U.S. NUCLEAR REGULATORY COMMISSION
REGION IV

Docket No.: 50-483
License No.: NPF-30
Report No.: 50-483/96-10
Licensee: Union Electric Company
Facility: Callaway Plant
Location: Junction Hwy. CC and Hwy. O
Fulton, Missouri
Dates: October 21 through December 9, 1996
Inspectors: I. Barnes, Technical Assistant
C. Beardslee, Materials Engineer
D. Graves, Senior Project Engineer
W. McNeill, Reactor Inspector
P. Rush, Materials Engineer
C. Dodd, NRC Consultant
Approved By: Kenneth E. Brockman, Deputy Director
Division of Reactor Safety

Callaway Plant NRC Inspection Report 50-483/96-10

Figure 1: Apparent circumferential defect on the 300 kHz plus point channel

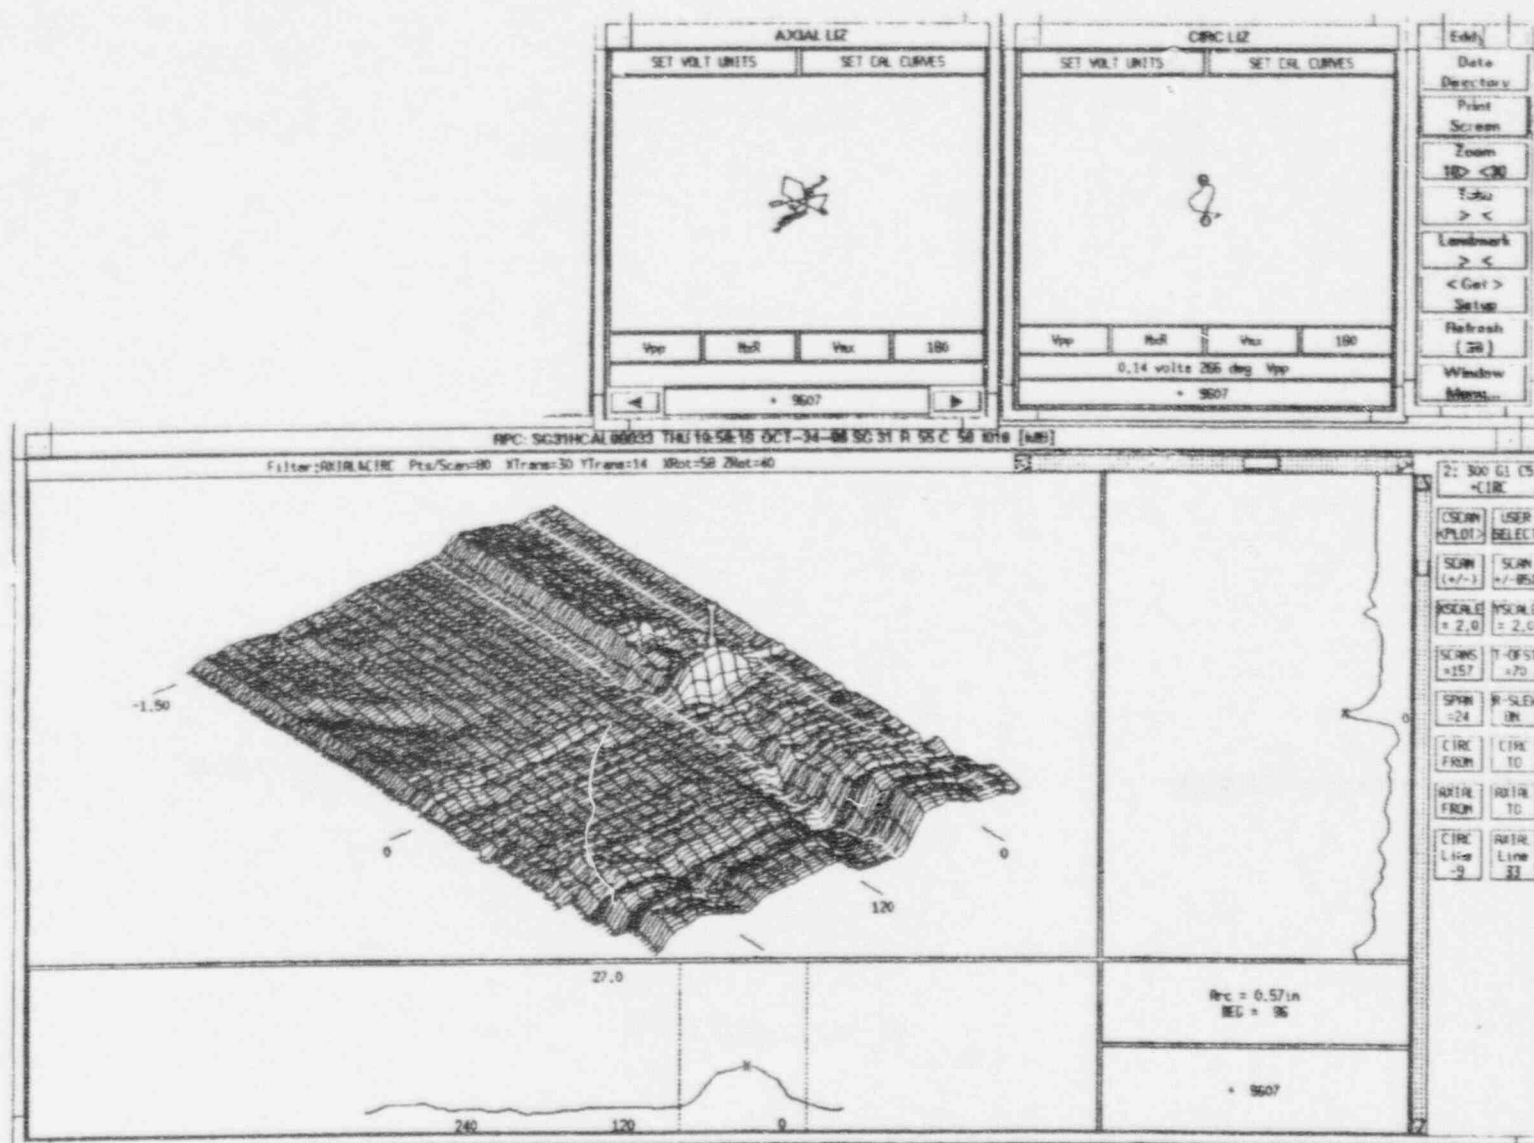
The inspectors noted that one type indication which appeared to lead to differing calls between analysts was when a ferromagnetic signal was present, such as in the tube located at Row 55, Column 50 in Steam Generator C. Figure 1 shows what appears to be a circumferential defect on the 300 kHz plus point channel. However, the inspectors concluded that the phase on lower frequencies did not rotate properly, and the signal from the locator channel (i.e., 20 kHz frequency) shown in Figure 2 displayed what appeared to be a ferromagnetic signal. The inspectors concurred with the licensee classification of the indication as a possible loose part and the actions taken to assure the structural integrity of abutting tubes.

Figure 3: Small axial indication at the top of the tubesheet in tube R9/C14 (SG-A)

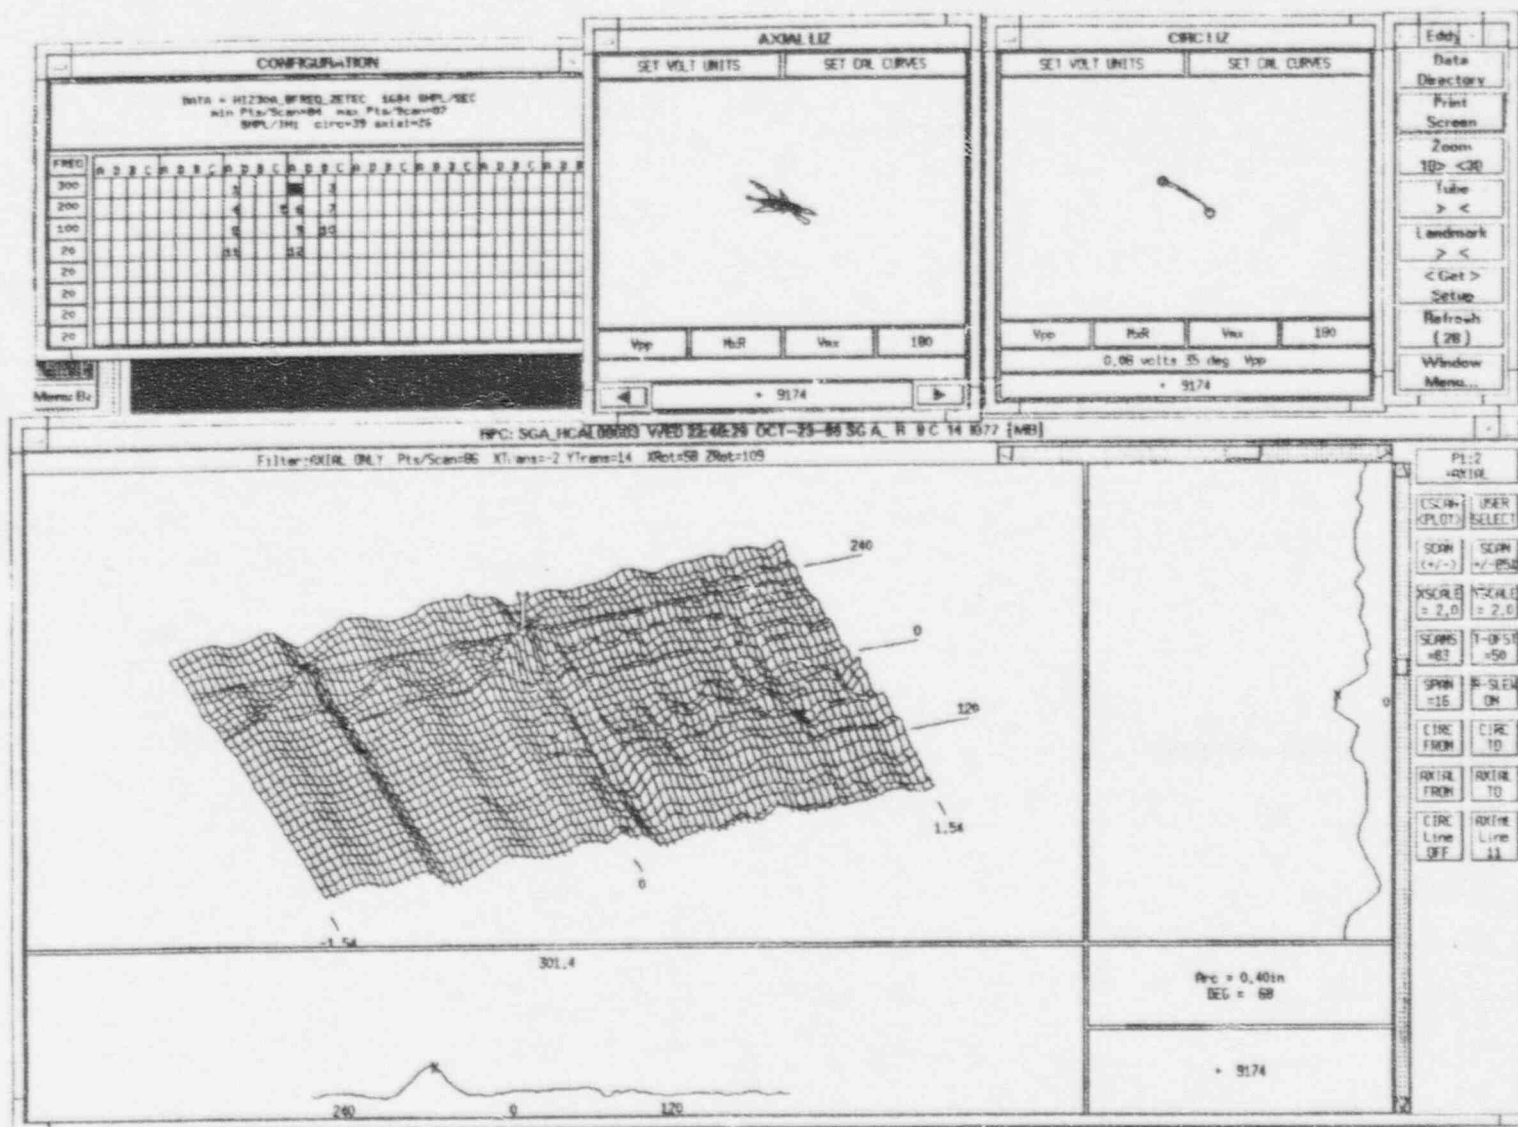
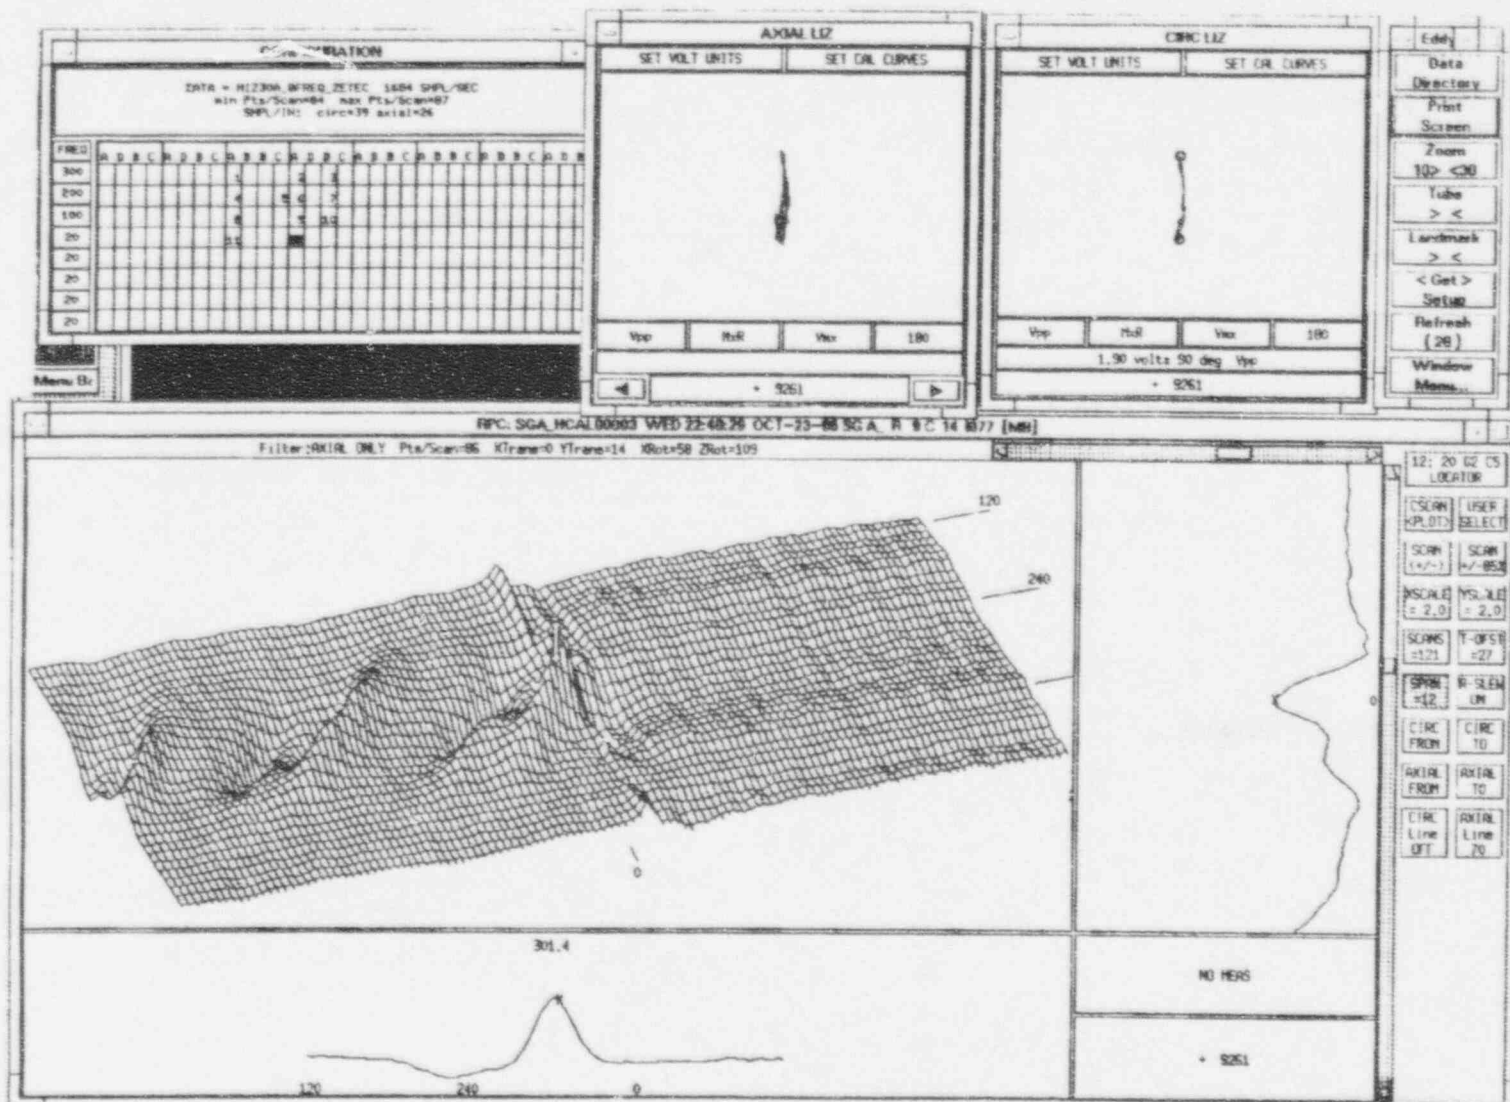
The inspectors identified another type of indication which did not appear to be associated with a known tube degradation mechanism and caused some disagreement between the two sets of analysts. The tube located at Row 9, Column 14 in Steam Generator A showed what appeared to be a small axial indication located at the top of the tube sheet (Figure 3). However, as seen in Figure 4, this indication is associated with a "ripple" on the locator channel. The resolution analyst postulated that this indication was either a rolling mark from steam generator fabrication, or it was due to cross talk between another probe acquiring data in the adjacent tube. This tube was initially called as containing a defect by the primary analyst, but it was eventually declared as no detectable degradation following resolution. The inspectors agreed with the resolution of this tube.

Figure 5: Lissajous signals for tubesheet expansion circumferential indication in tube R21/C48 (SG-A)

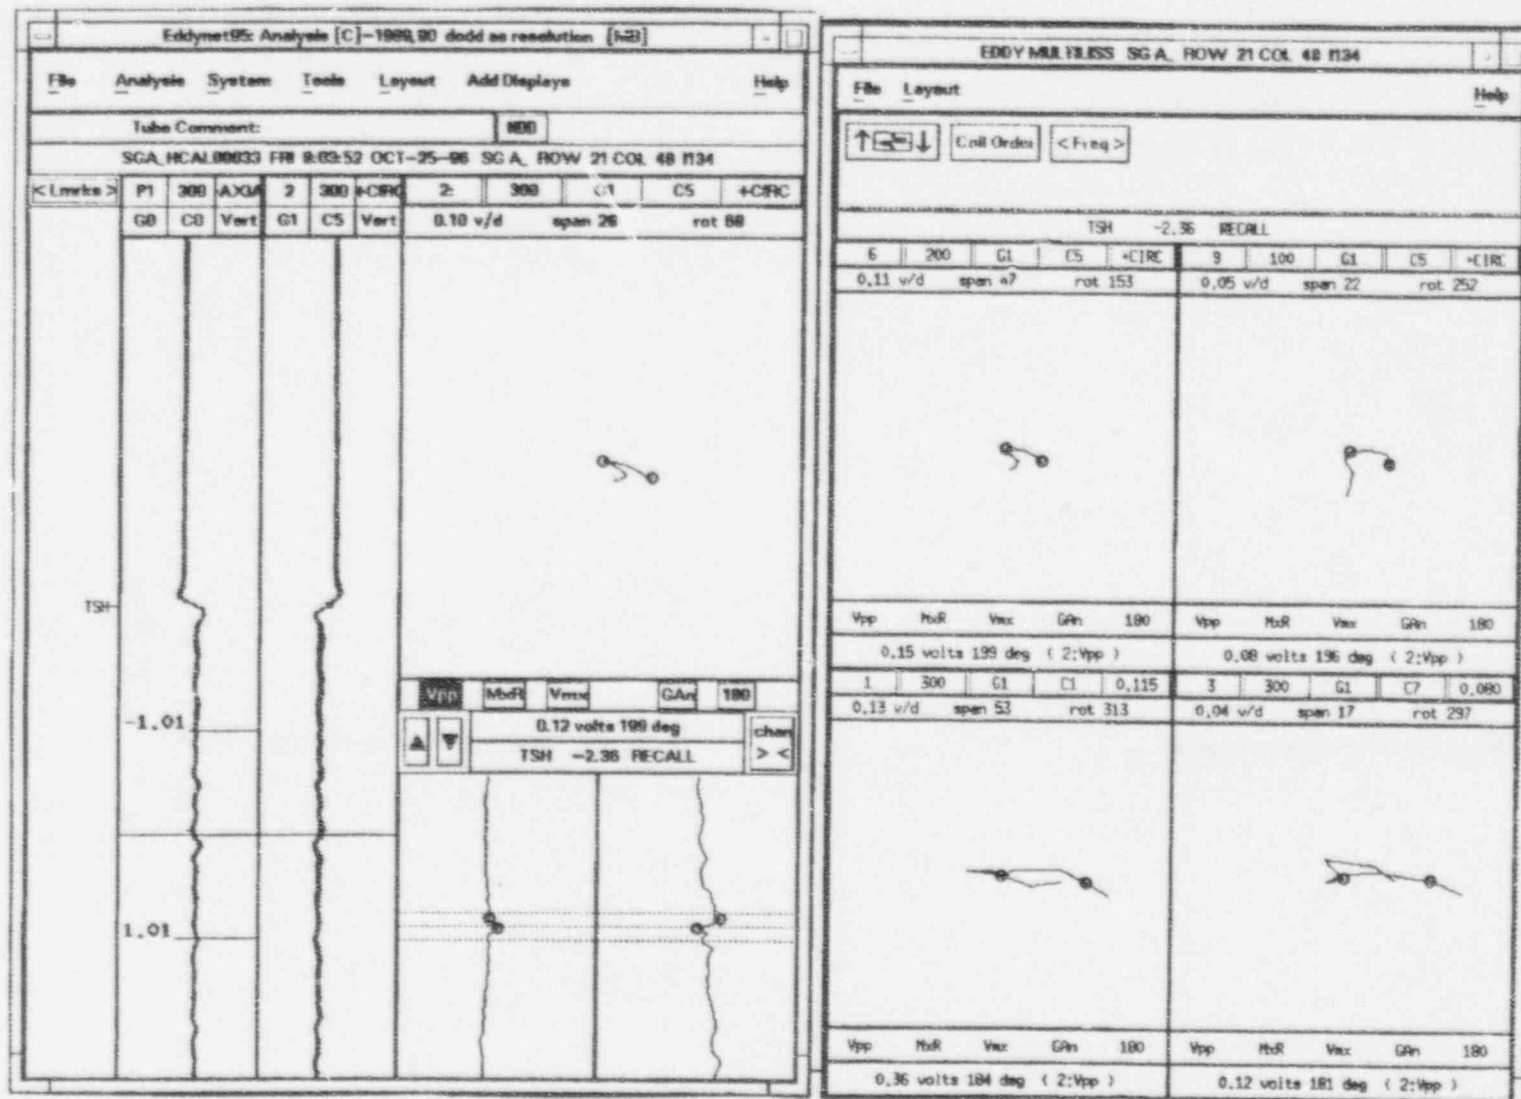
The inspectors also completed an independent data review of a sample of tubes resolved as containing defects based on the inspection data. Although several of the indications were detectable using all the inspection coils, the inspectors qualitatively concluded that the majority of indications reviewed in the sample appeared to be small. This was evidenced by the fact that these smaller indications were detectable with the plus point coil, but did not exhibit detectable degradation with the pancake coils. For example, the tube located at Row 21, Column 48 in Steam Generator A was called as a single circumferential indication below the top of the tube sheet. As shown in Figure 5, the phase of the indication is consistent with defects for the plus point at 300 kHz, 200 kHz, and 100 kHz. However, this indication was not detectable on the 300 kHz frequencies for the 0.115-inch pancake and the 0.080-inch pancake coils. The licensee elected to sleeve the tube.

Figure 6: Multiple circumferential indication at the top of the tubesheet in tube R17/C57 (SG-A)

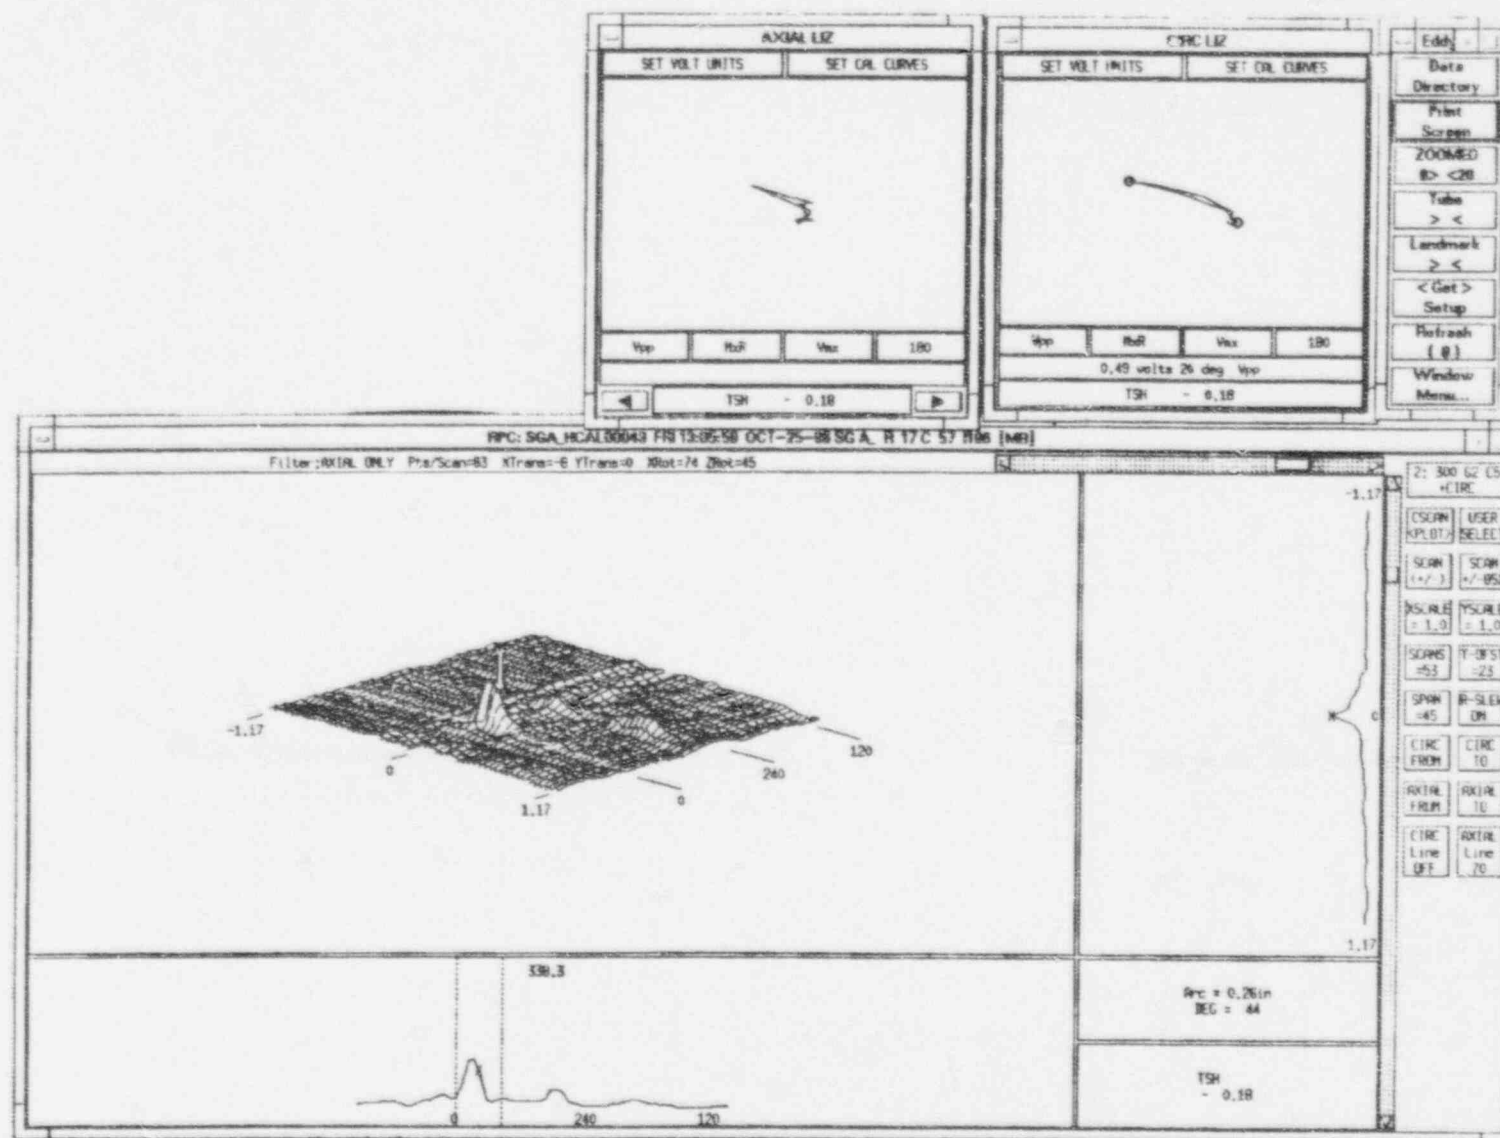
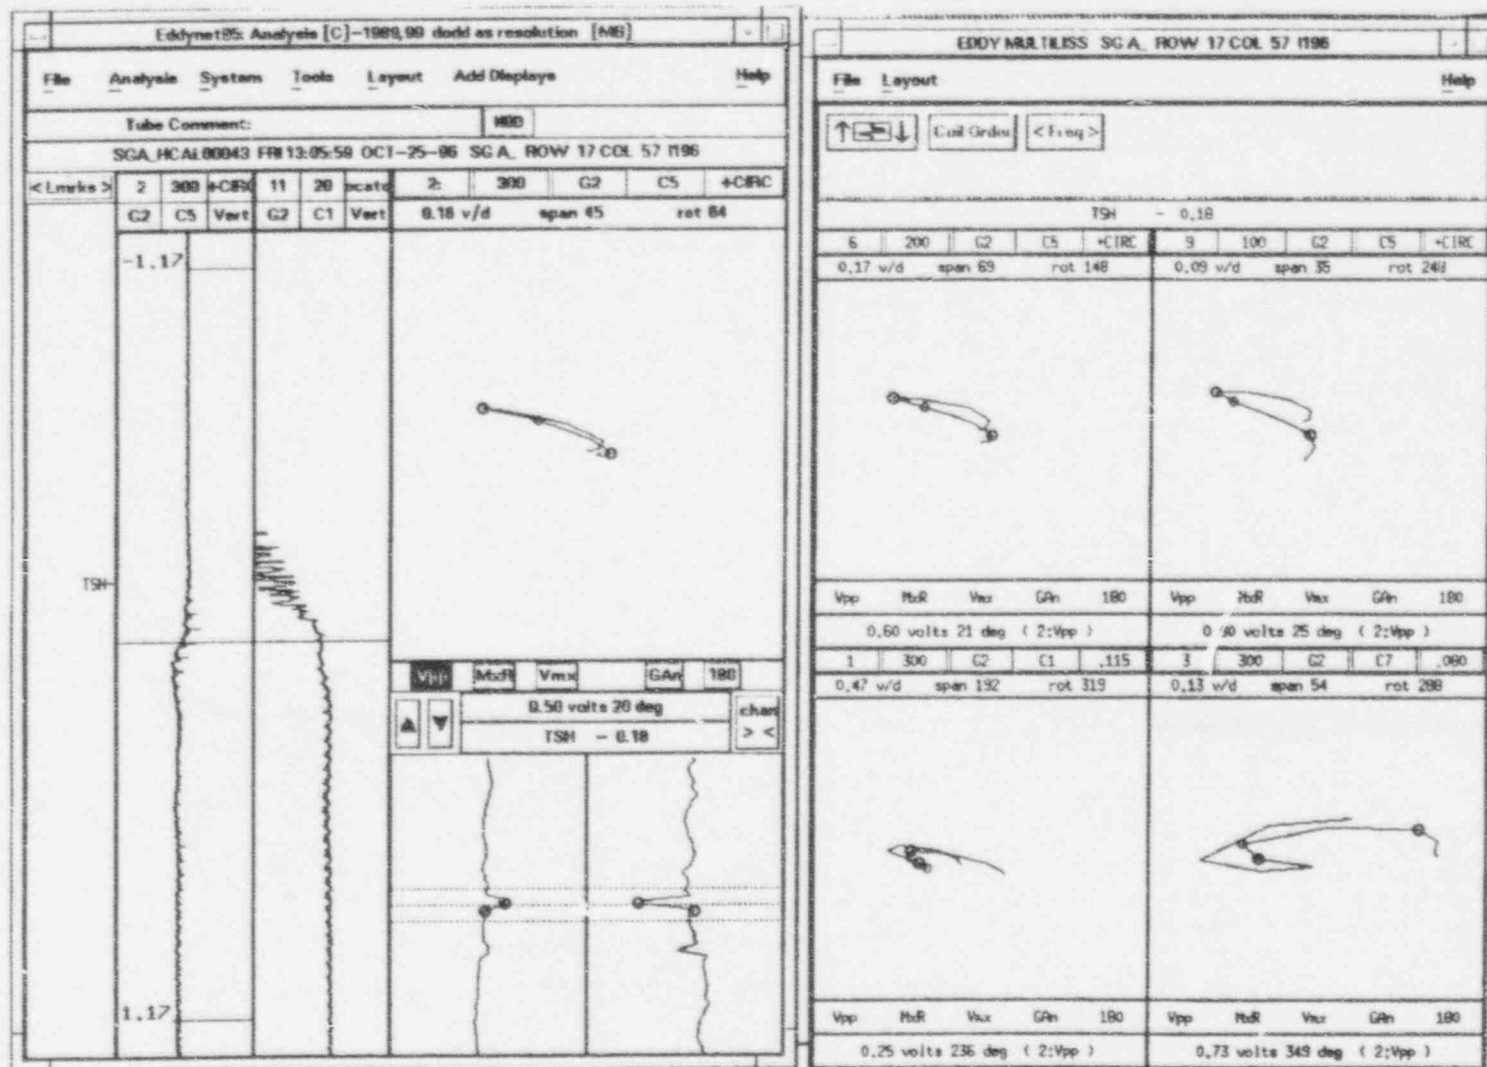
One of the larger indications reviewed during the data assessment was in the Steam Generator A tube located at Row 17, Column 57. Figure 6 shows data obtained from this tube which was called as containing multiple circumferential indications at the top of the tube sheet. As shown in Figure 7, the phase of the signal is consistent with defects for the plus point at 300 kHz, 200 kHz, and 100 kHz. Although the indications was one of the larger signals seen with the plus point coil, this indication was only marginally detectable on the 300 kHz frequencies for the 0.115-inch pancake and the 0.080-inch pancake coils. The licensee declared this tube defective, and elected to sleeve the tube.
